Extra Class License Manual – Supplemental Information and Errata

The following text is intended to support or correct the 12th edition of the *Extra Class License Manual* and the 5th edition of the *Extra Class Q&A*. **Recent changes in this version of the document are in red.**

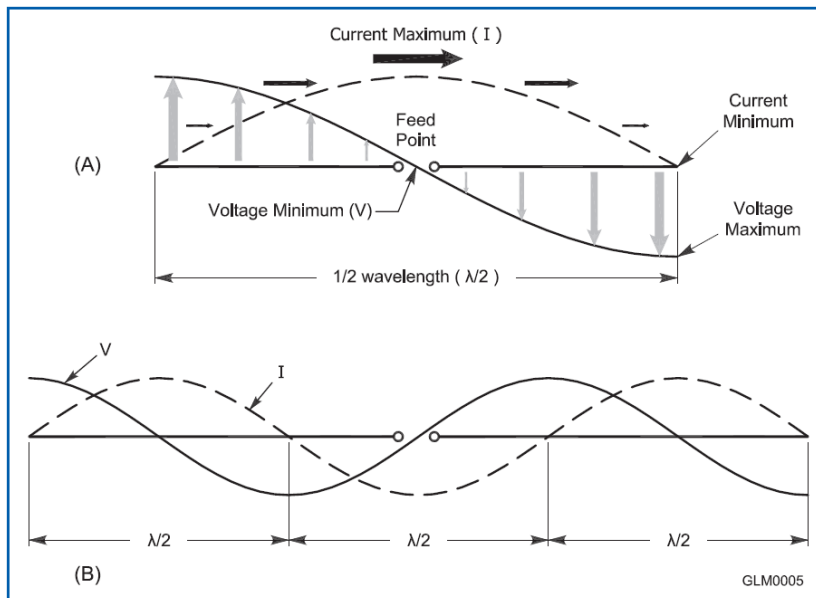
A resonant antenna has a feed point impedance that is all resistance. i.e. $Z = R + j0$. Yet the current and voltage appear to be 90 degrees out of phase at resonance – why?

The drawing above shows the current and voltage distributions. The distributions along the wire are just the magnitude of the waveforms (like the envelope of a modulated signal) and doesn't say anything about the phase of the actual waveform. It is the distributions that are 90 degrees out of phase, not the waveforms. At the center, the voltage waveform reaches a minimum while the current waveform is at a maximum - yet both waveforms are in-phase (at resonance), resulting in a purely resistive impedance.
